00 91 01 ADDENDUM #2

Owner: Cobb County-Marietta Water Authority
Project: Blackjack Mountain 36-inch Pipeline Replacement
Project No.: 505-9005-30-19-0000/CBR18759
Addendum No. 2
Addendum Date: April 24, 2020

4
 C-8
SEGMENT A
CONNECTION STA 92+68
8" CCWS CONNECTION AT HOLT RD

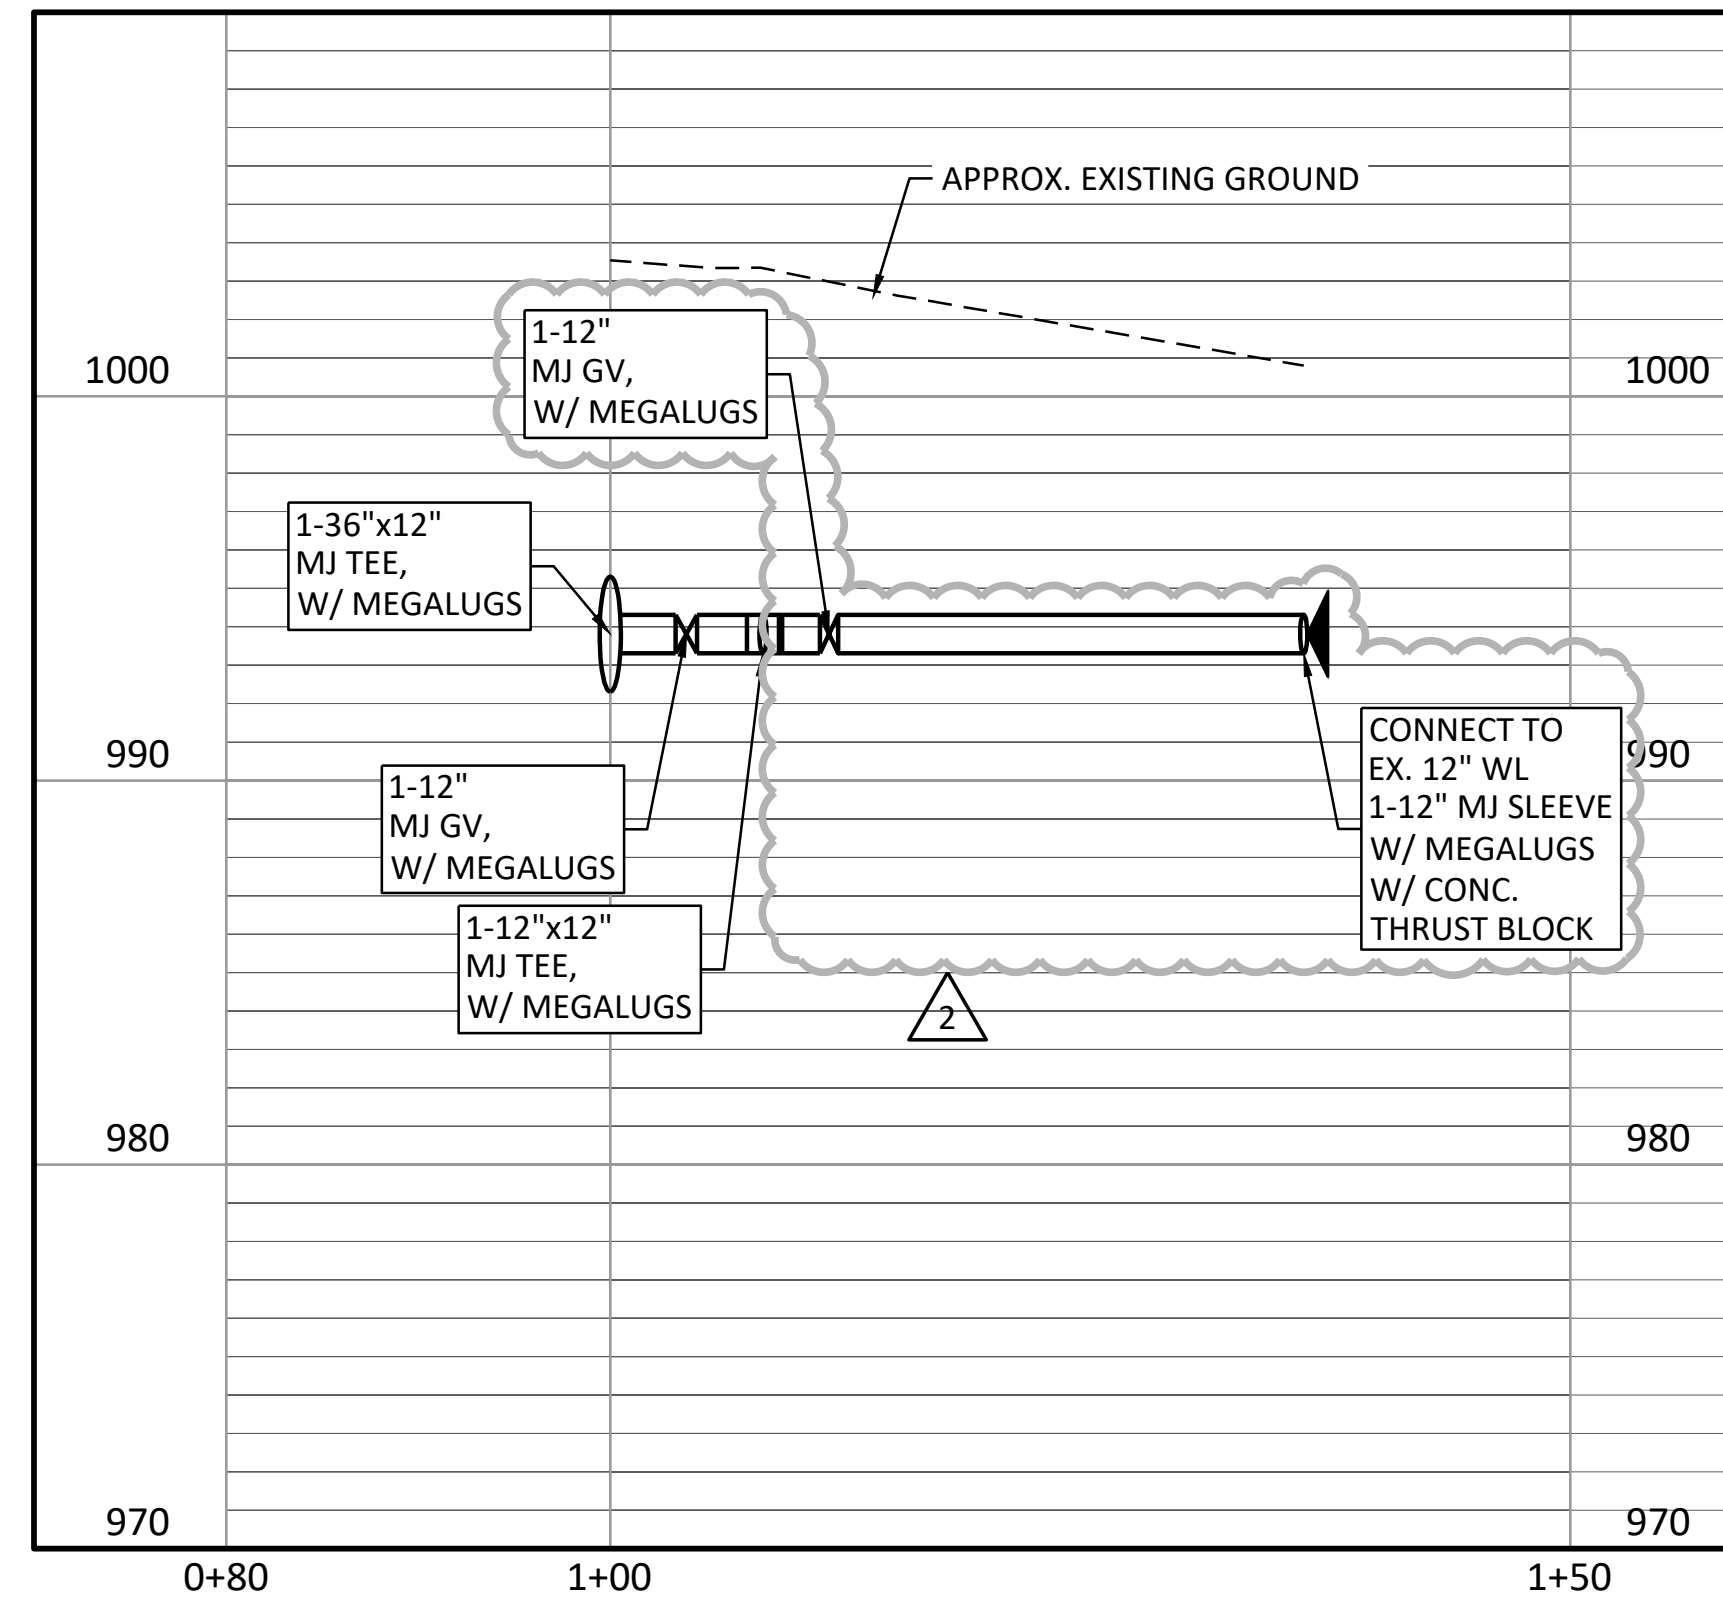
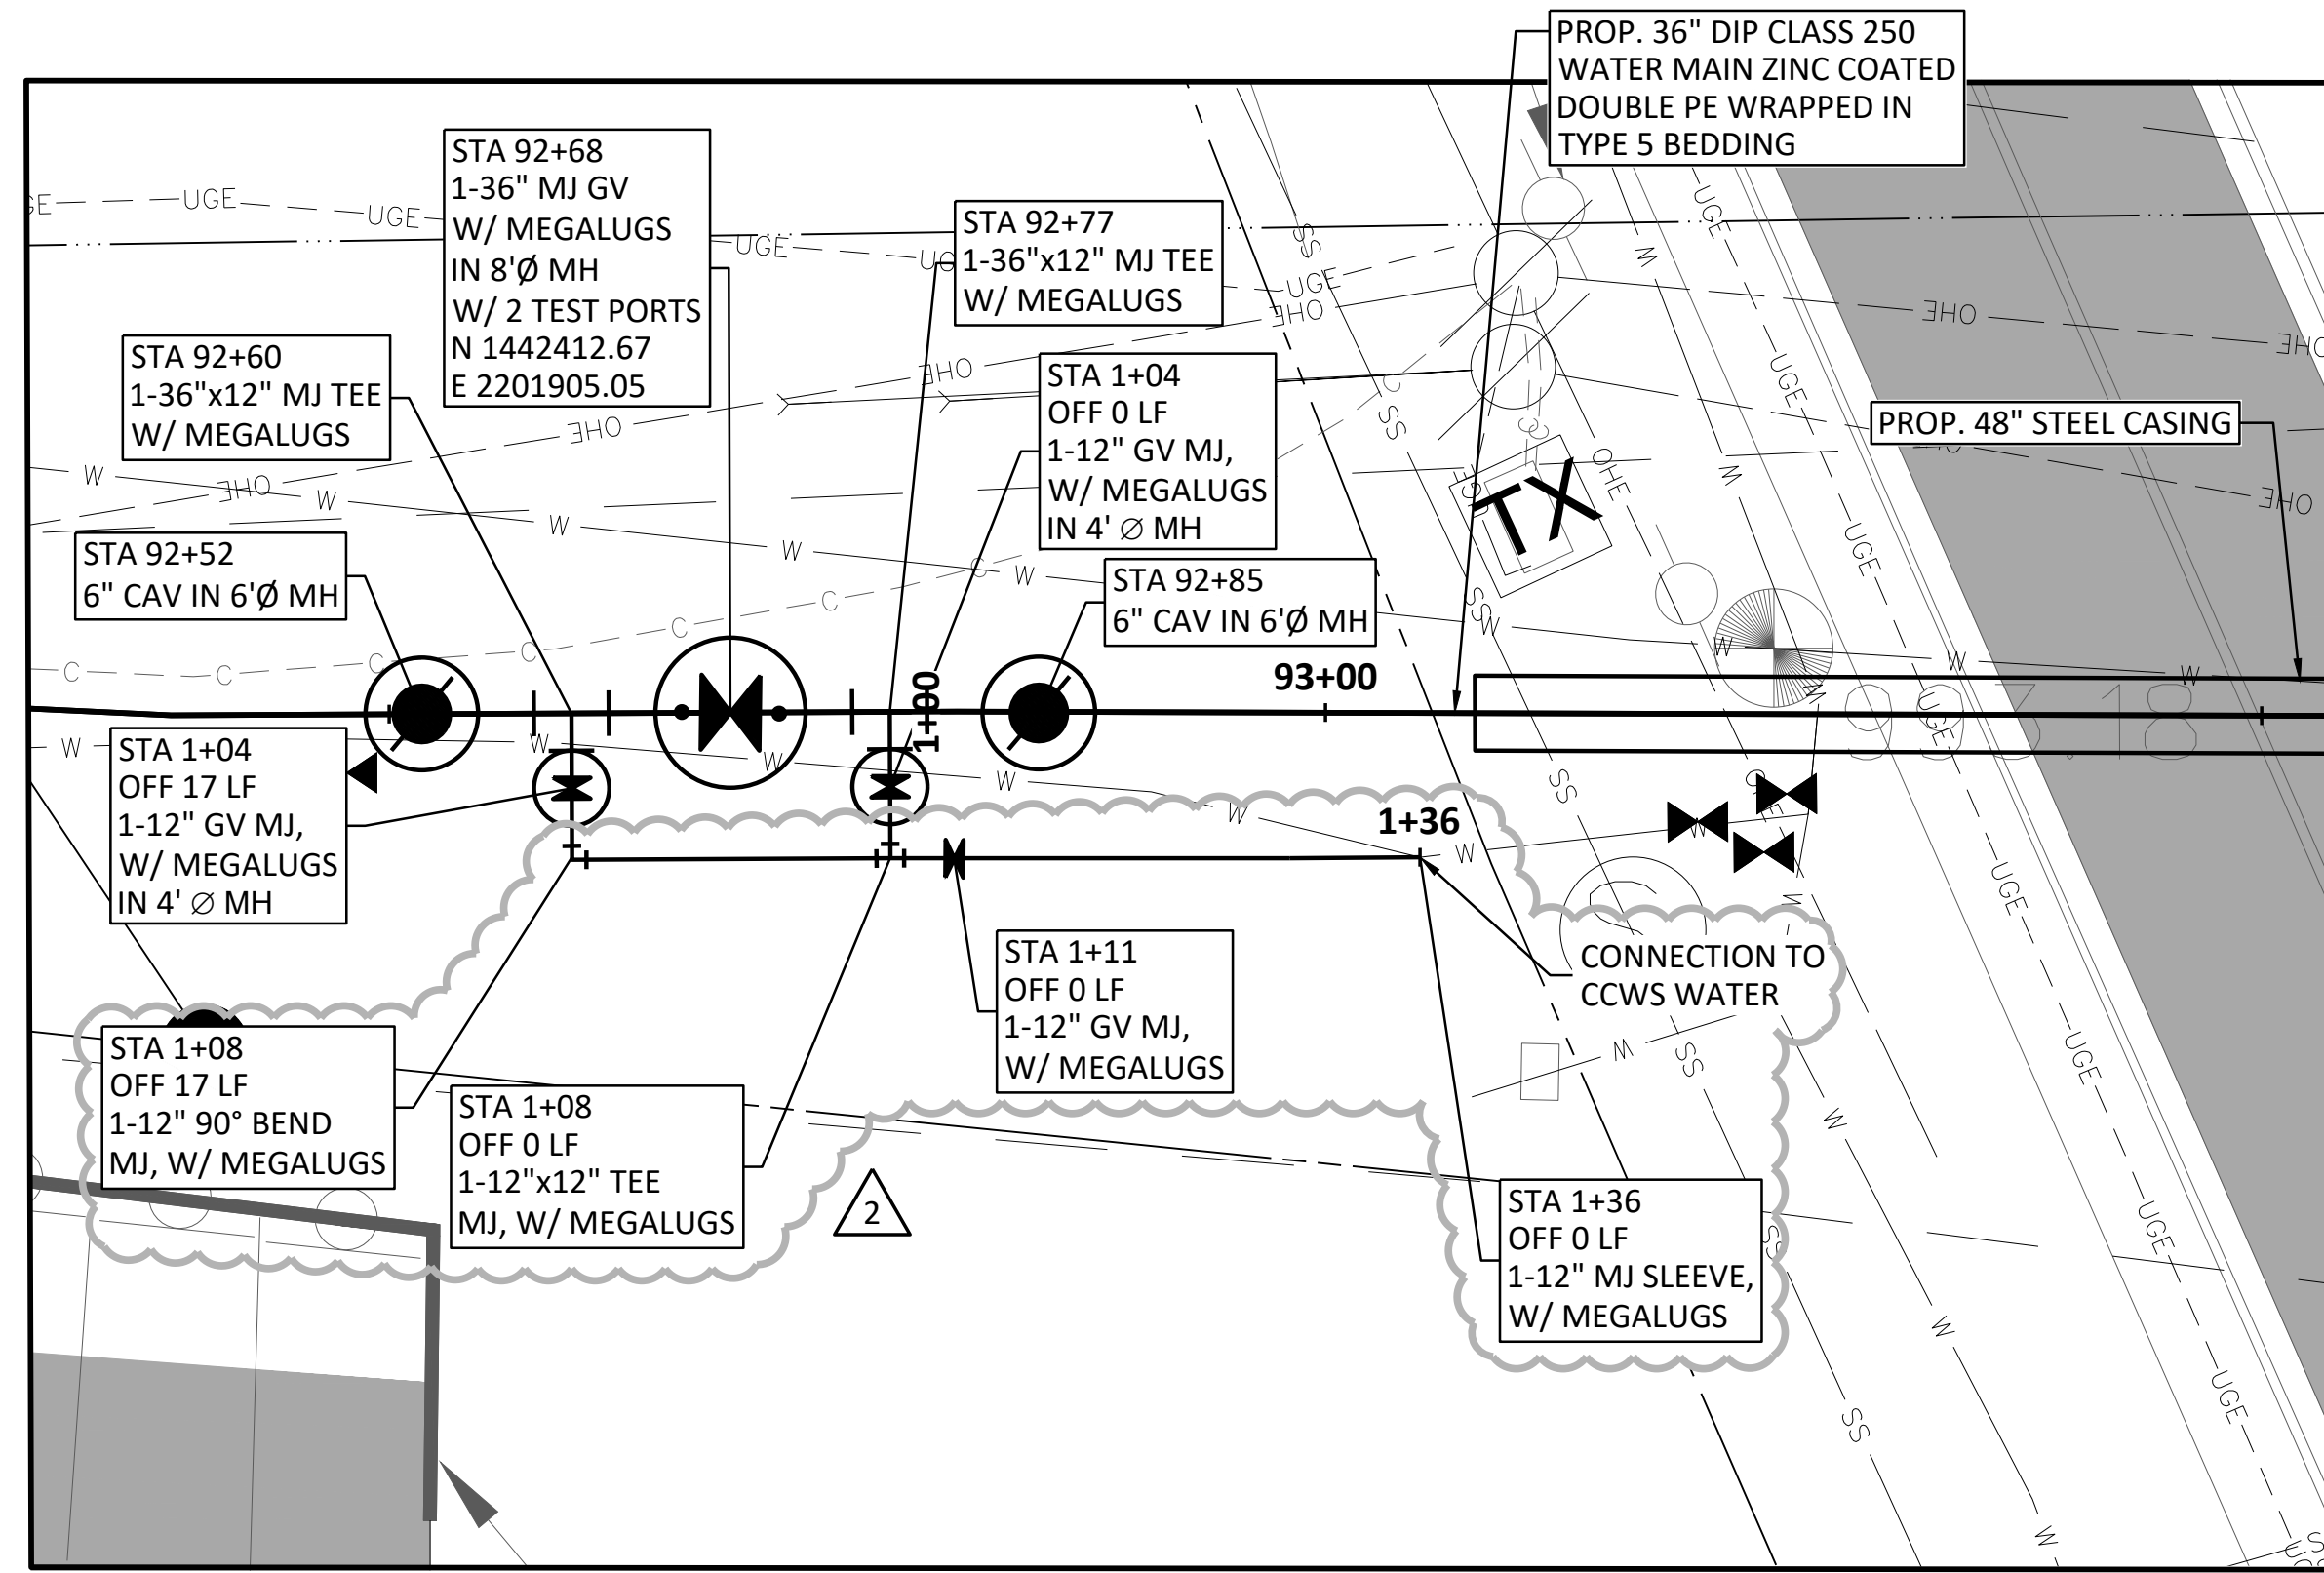
6.34 Question: Reference Sheet C-4 station 49+50 and CD-2. Sheet C-4 shows the 36" main to be approximately 14' deep while sheet CD-4 shows it to be about 27' deep. Can you provide information to clarify this?

Answer: This item has been addressed in Addendum 1.

DOUBLE BLOWOFF VALVE INSTALLATION DETAIL (STA 164+18)
 N.T.S. **120A**

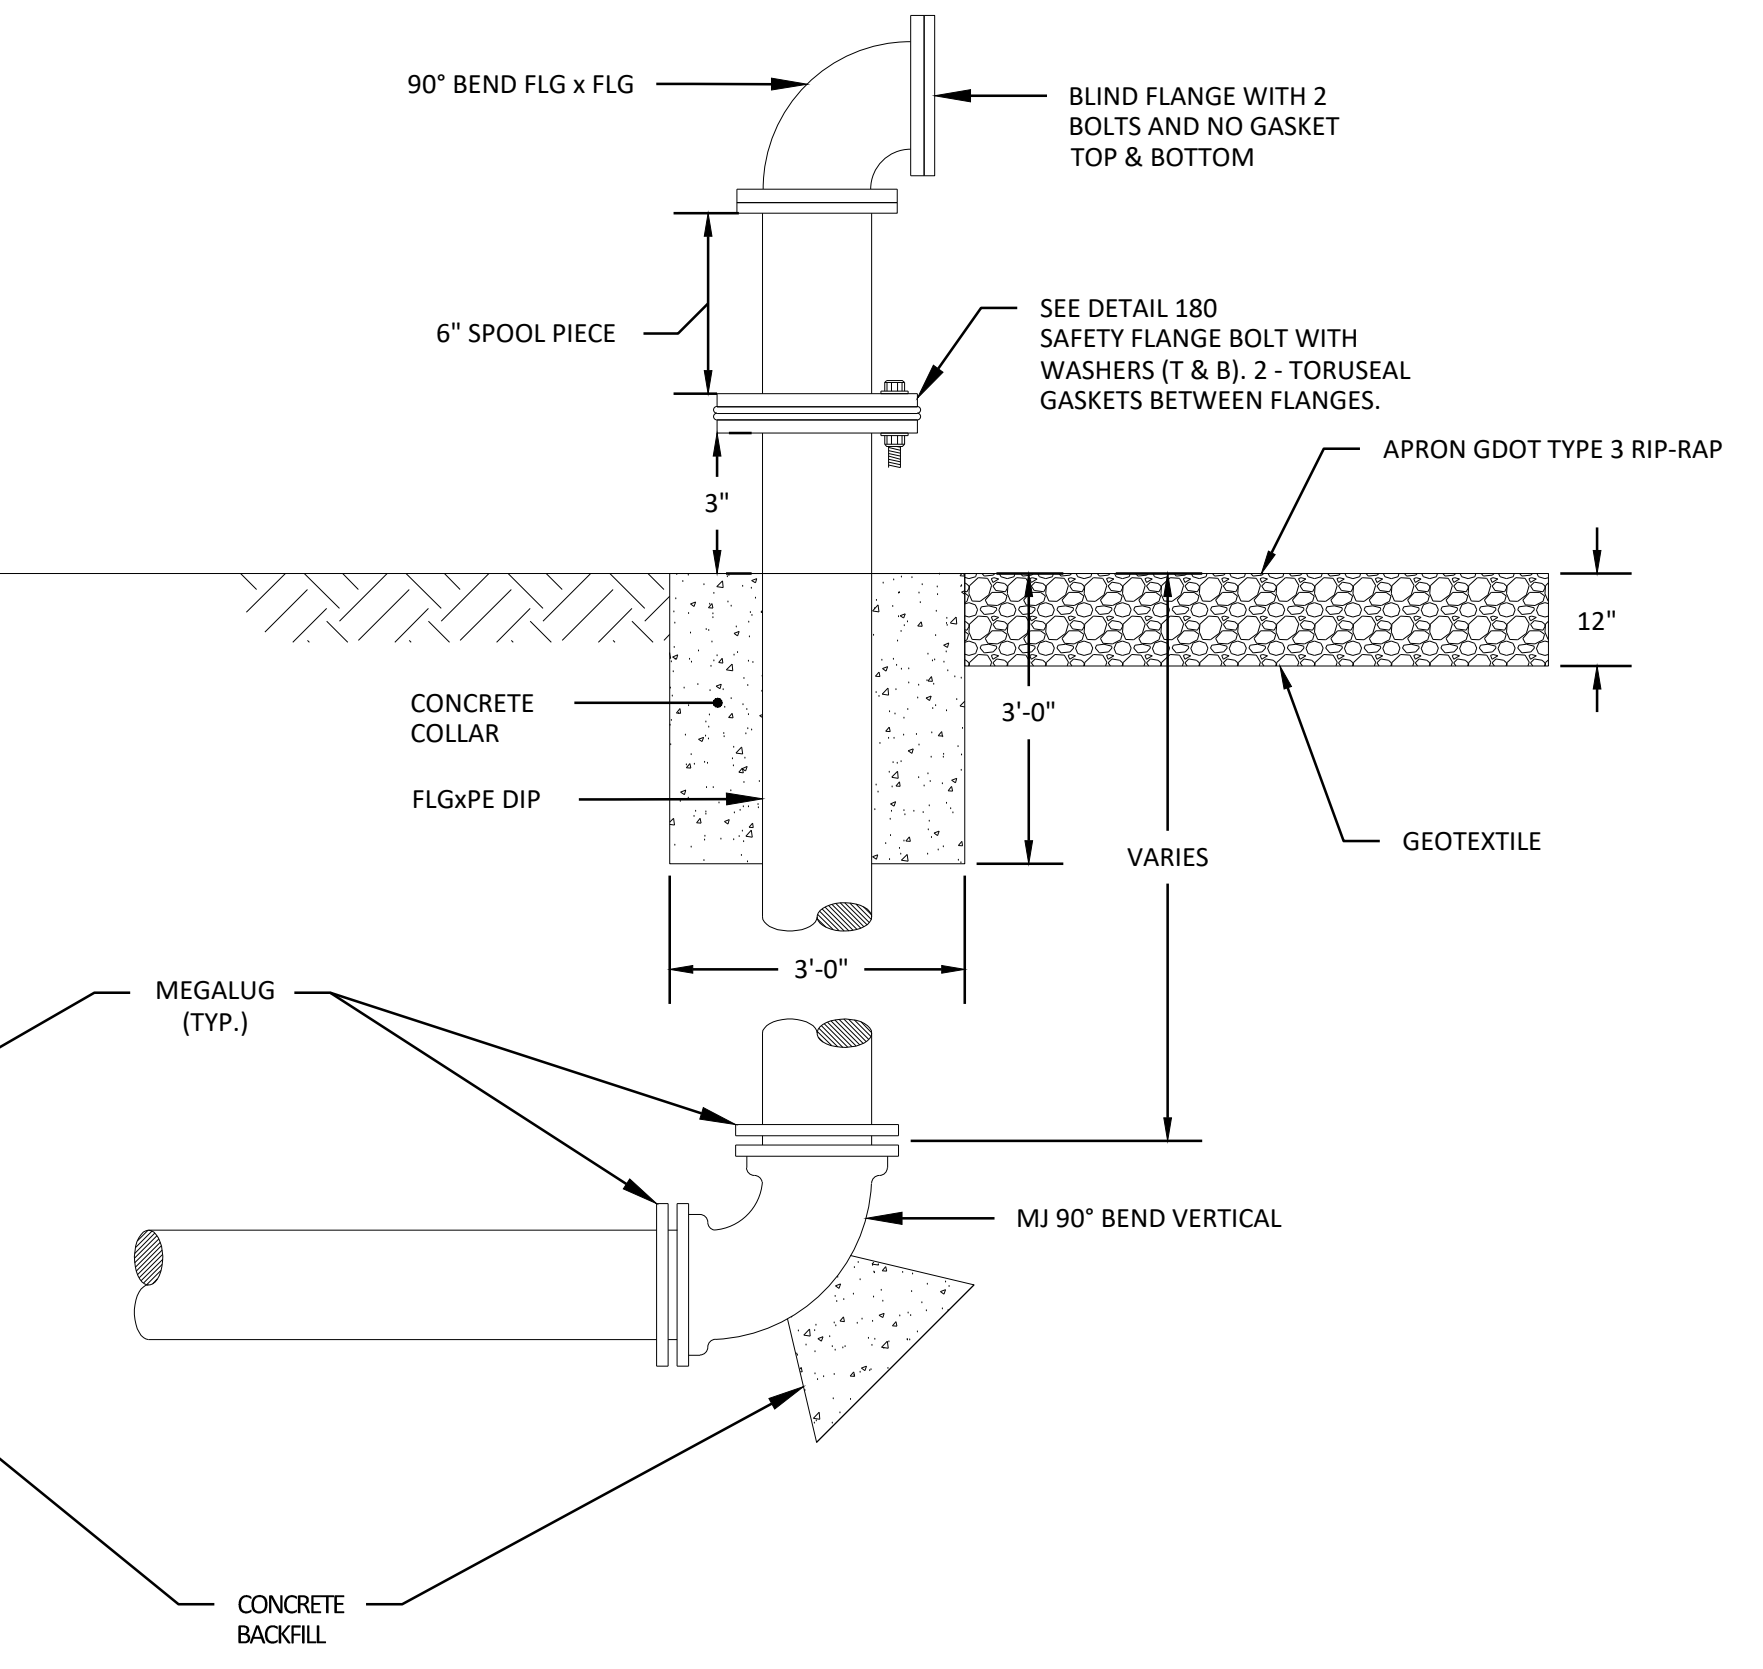
6.40 Question: Is the additional components @ STA 164+18 on segment A in the plan view in addition to the components called out in a "single MH" BOV detail setup?

Answer: A blowoff valve manhole detail will be provided in the contract addenda.
